From: Barr, Michael <Michael.Barr@dot.state.fl.us>
Sent: Wednesday, September 23, 2015 9:38 AM
To: Scott, Jimmy
Cc: Koontz, Lori; Marchese, Deborah; Hinton, Joseph; Jeff Begovich; Robert Rudd; D5-Construction Special Projects
Subject: 435515-1 Field Review Lake Co Hancock Rd Ext
Attachments: 435515-1 Field Review 2015.09.22.pdf

Project Name / Description: Hancock Rd Four-lane Extension Phase III A from CR 50 to Fosgate Rd	
FPN / Contract #: 435515-1-58-01 / ARC76 / Fund: TRIP	
Agency: Lake County / Terry Scott	Contractor: Pospiech Contracting Inc / Gary Brac
County: Lake	Location: Minneola
Type of work being performed:	
Construction of new 4-lane roadway, bike lanes, curb & gutter, sidewalks and/or multi-use paths from Old Highway 50 / CR 50 to Fosgate Rd.	
General Comments:	
The purpose of the visit was to verify the progress of construction on the Project. Attended Weekly on-site Progress Meeting (# 22) for project status update. According to the CCEI, the project has had some minimal changes and adjustments and is about 2 months ahead of schedule.	
Local Program Coordinator: Michael Barr	Date: September 22, 2015

From: Scott, Jimmy
Sent: Monday, September 21, 2015 10:33 AM
To:

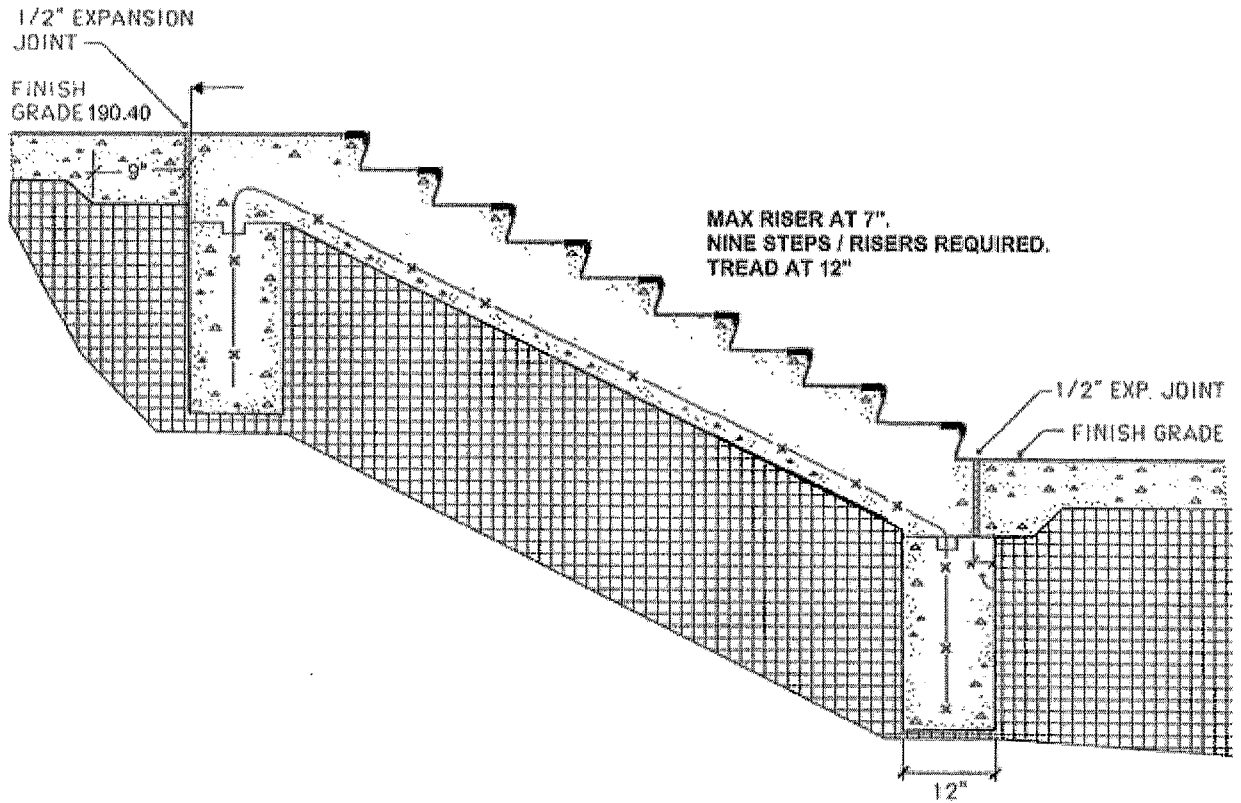
The sidewalk ramp also being included correct?

See revised stairs detail. Nine risers will be needed. Confirm this would be accessible before I proceed with next elements of design.

Couple of details for review / comment

That is correct.

These steps and the ramp will be installed at the walk through gate for the school between the main entrance and Fosgate. I will get with you explain.
Thanks.
